IFB T990043/SU-021119: Perception Lab Renovation Addendum #1 * February 26, 2020

Re: Addendum No. 1 to specifications SU-021119
Visual Arts Perception Lab Renovation – Electrical, Mechanical drawing changes

DATE: FEB 26TH, 2020

DRAWING NO.
E-003

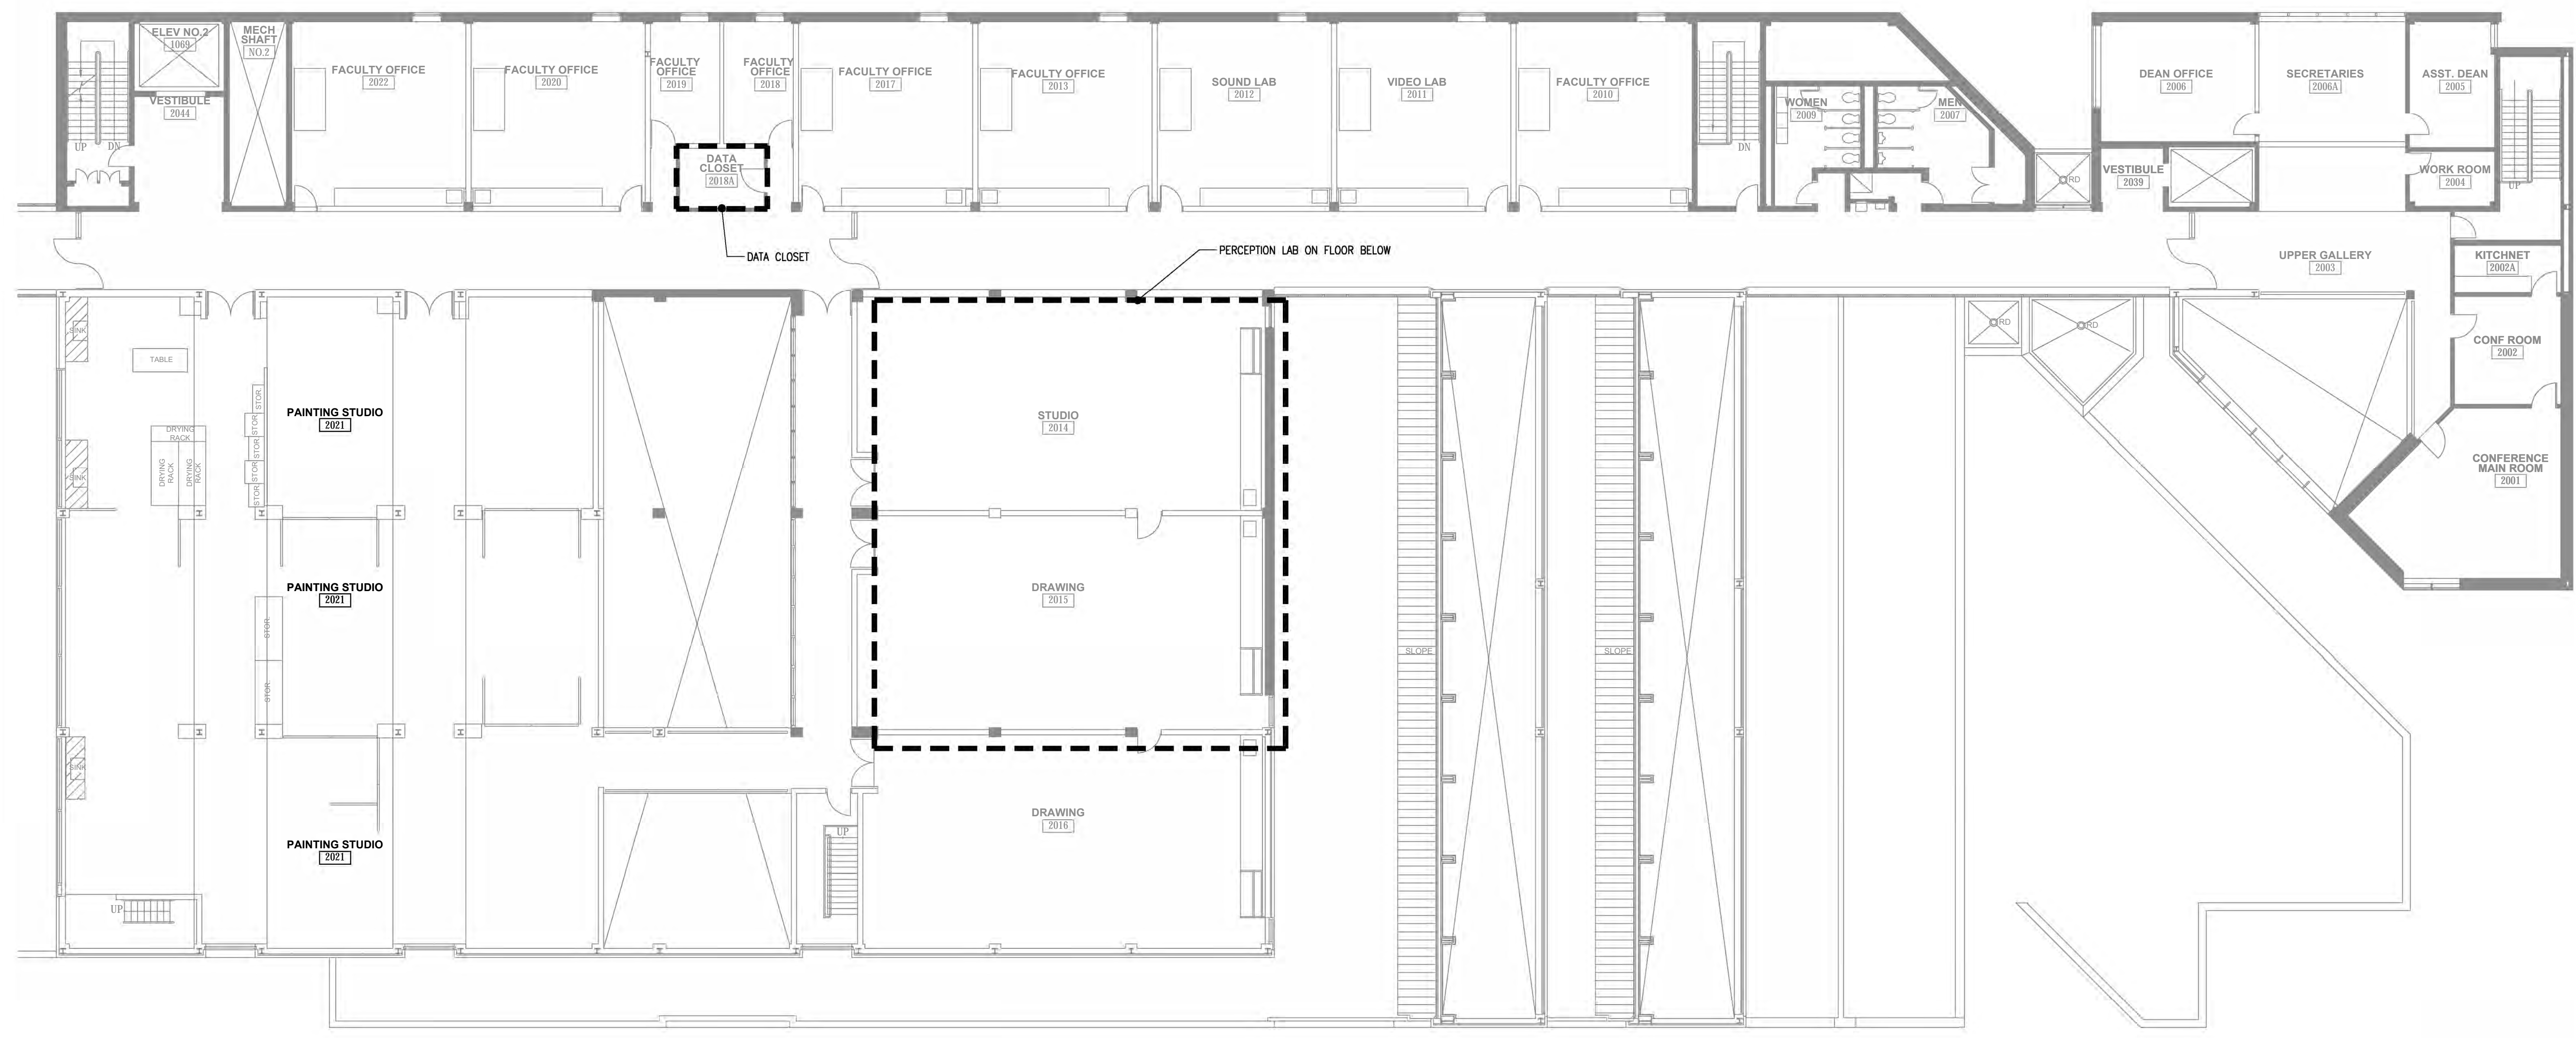
- 1-Addition of specs for low voltage modular cables, jacks and faceplates
- 2-Addition of a patch panel and patch cords in the CTS closet
- 3-Removal of note to correct reference to an alternate

NOTE: CONTRACTOR SHALL PROVIDE THE FOLLOWING SCOPE: CAT 6 CABLE, CAT6A CABLE, 24-PORT MODULAR PATCH PANEL AND 24 PATCH CORDS IN DATA CLOSET. ALL DATA CABLES SHALL BE PROVIDED FROM DATA CLOSET ON SECOND FLOOR TO PERCEPTION LAB ON FIRST FLOOR. CAT6 CABLE SHALL BE PROVIDED FOR ALL IT OUTLETS UNLESS OTHERWISE NOTED: HITACHI PREMIUM ENHANCED UTP CAT6 CABLE, OR APPROVED EQUAL. CAT6A CABLE SHALL BE USED FOR WIRELESS ACCESS POINTS: HITACHI SUPRA 10G ENHANCED UTP, OR APPROVED EQUAL. PATCH PANEL: LEVITON 24-PORT QUICKPORT PATCH PANEL 49255-L24, OR APPROVED EQUAL. PATCH CORDS (24 TOTAL): LEVITON ATLAS-X1 6AS10, OR APPROVED EQUAL. CONTRACTOR TO PROVIDE ALL LABELING AND TESTING, AS PER CAMPUS NETWORK CABLE INSTALLATION SPECIFICATION.

DRAWING NO.
M-101

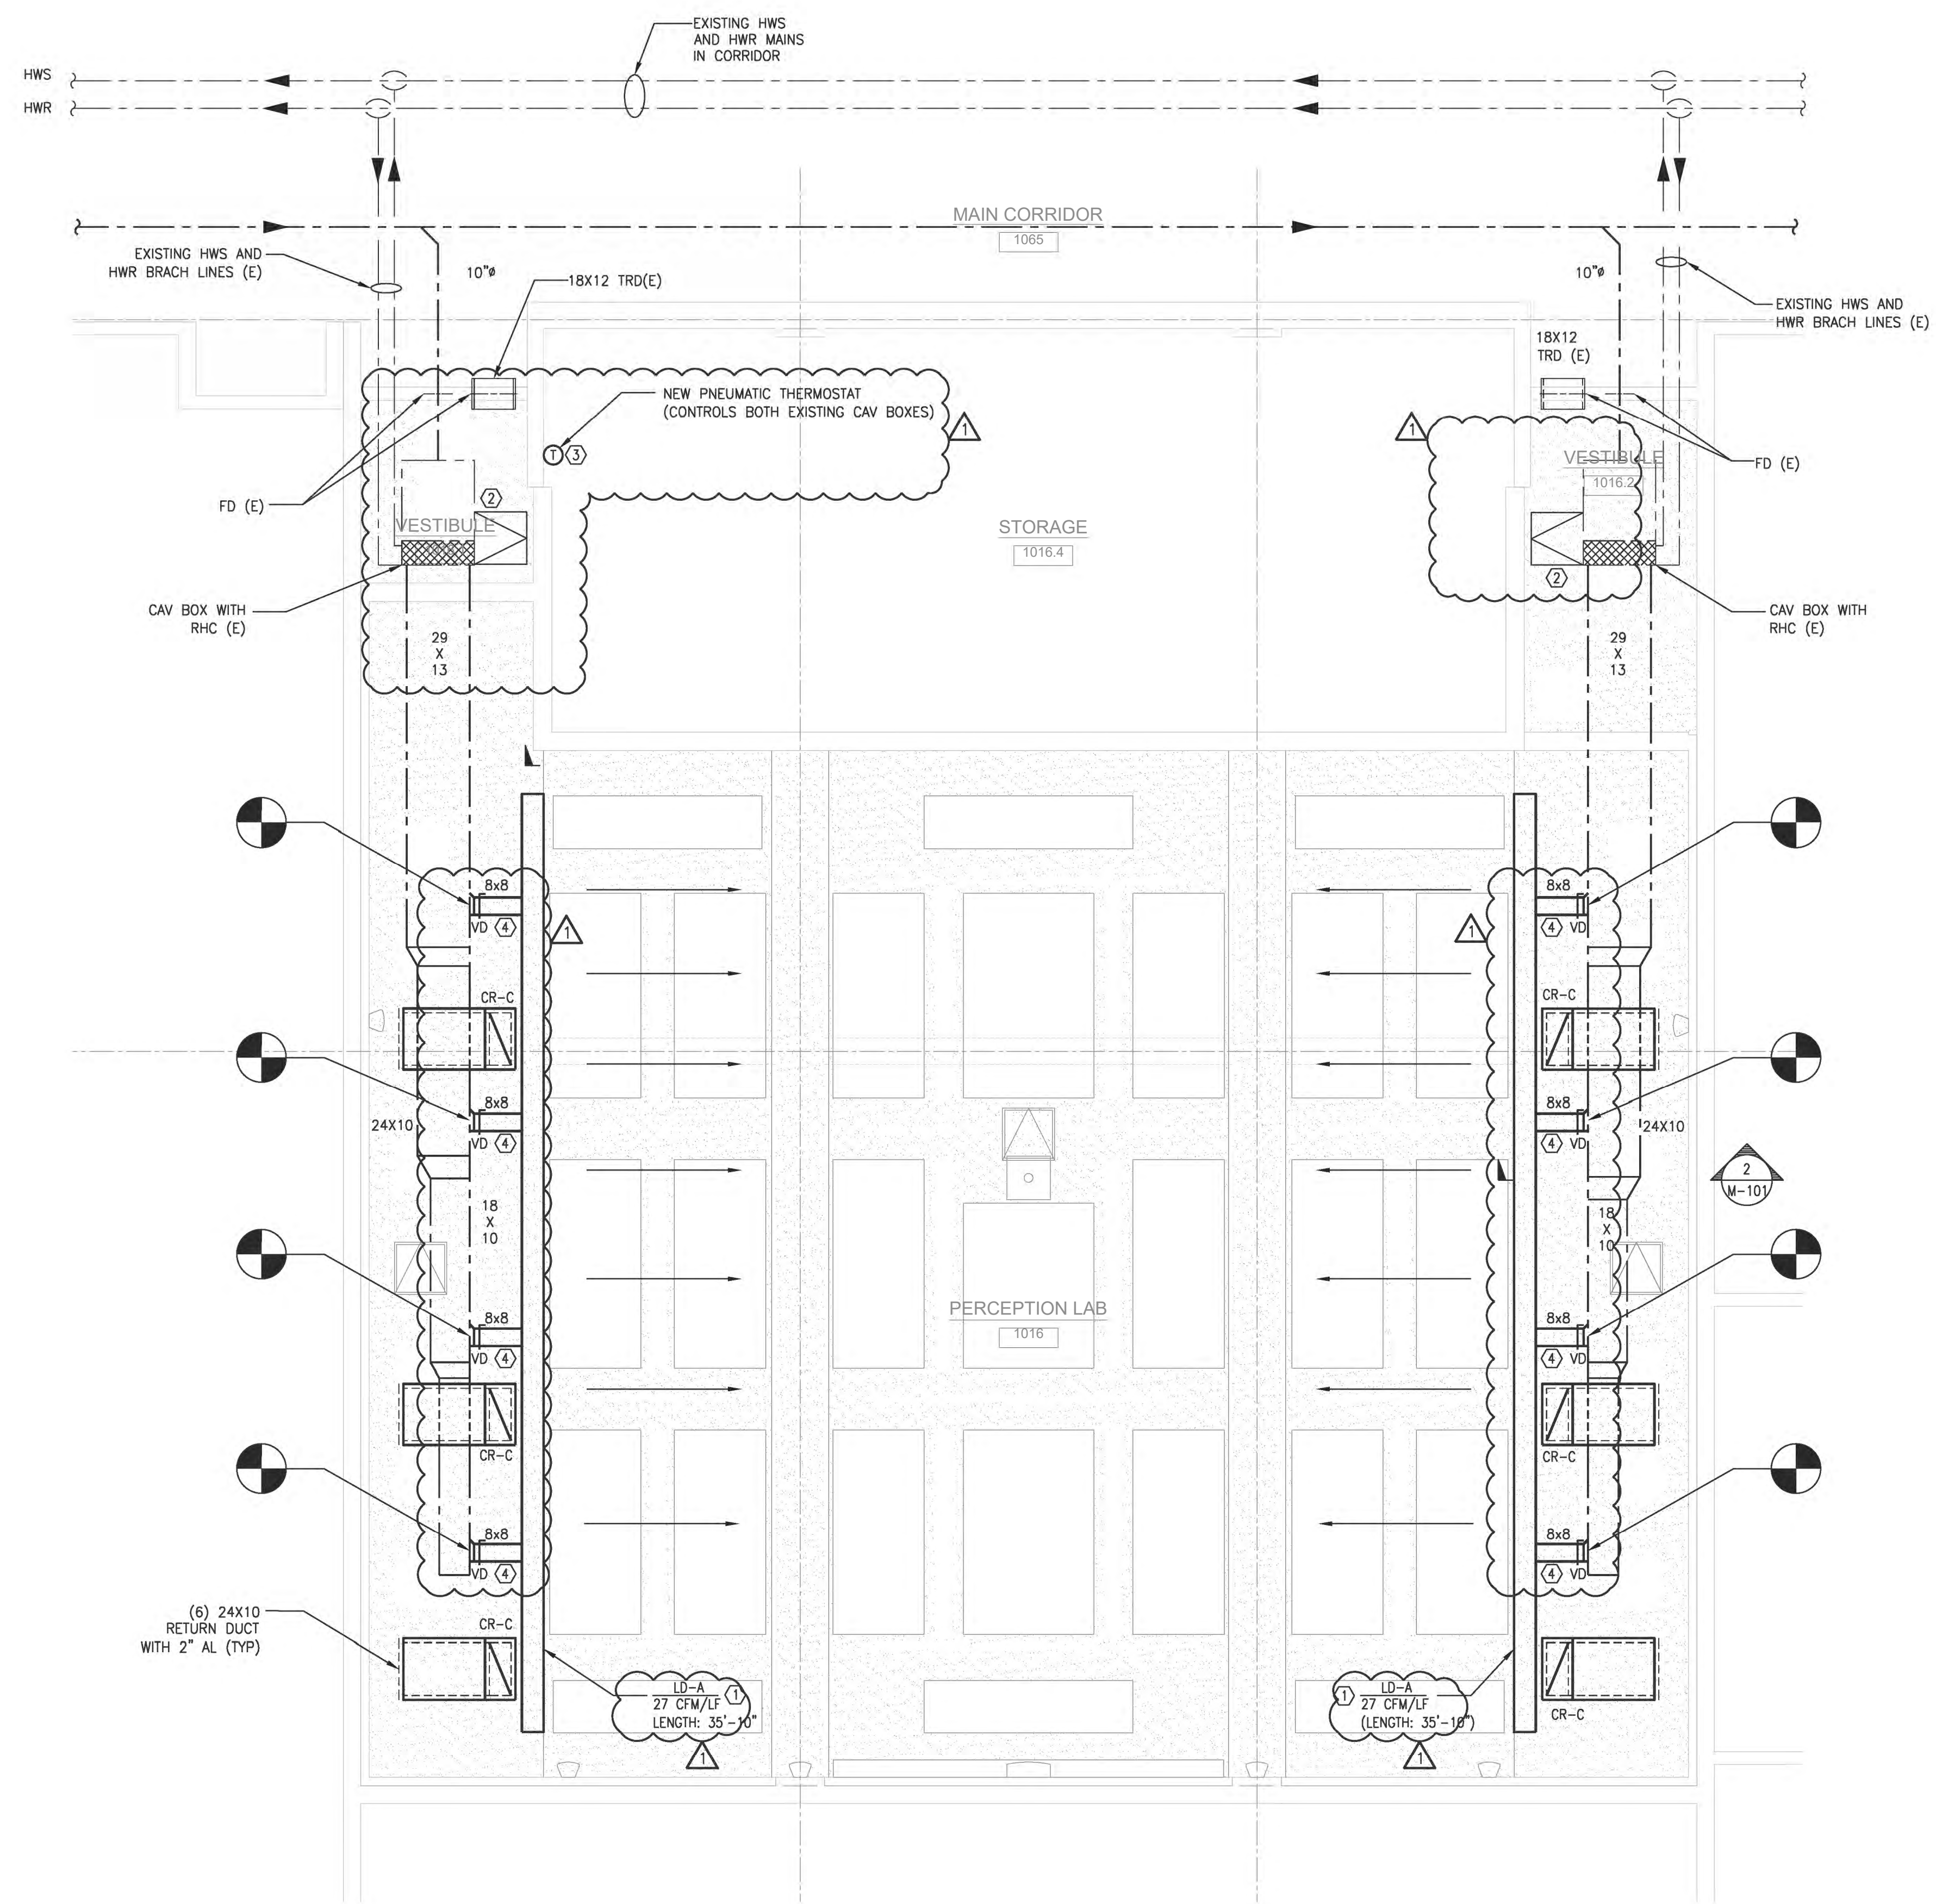
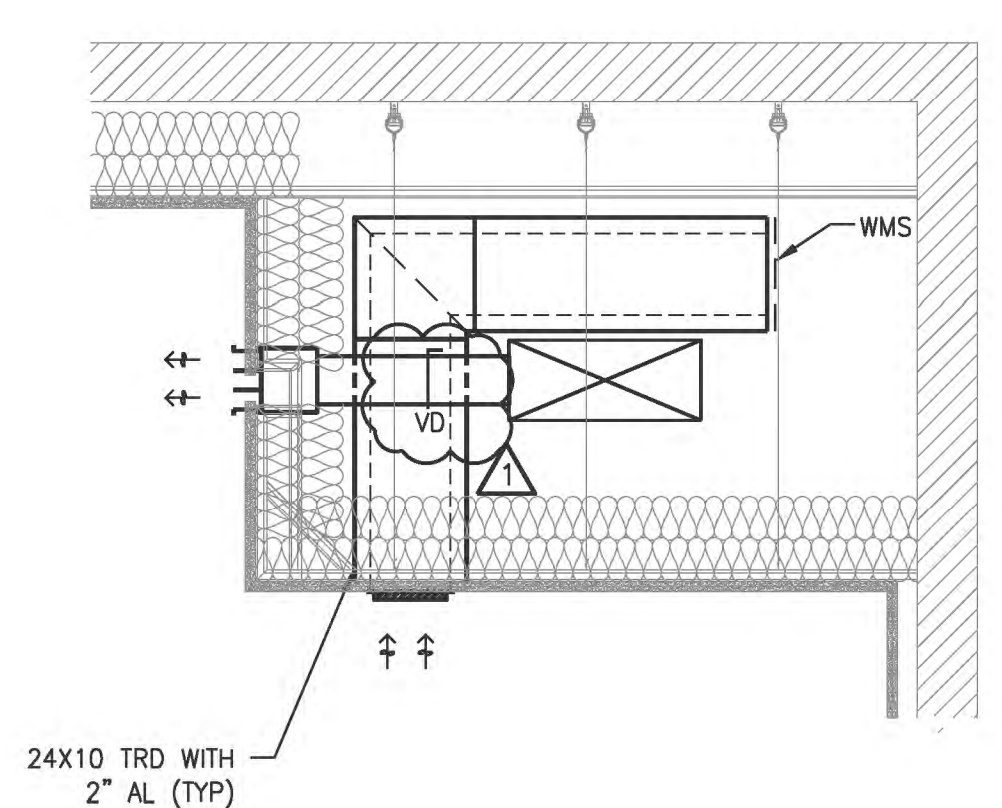
- 1- DDC to Pneumatic thermostat change
- 2- Removal of wall penetration details
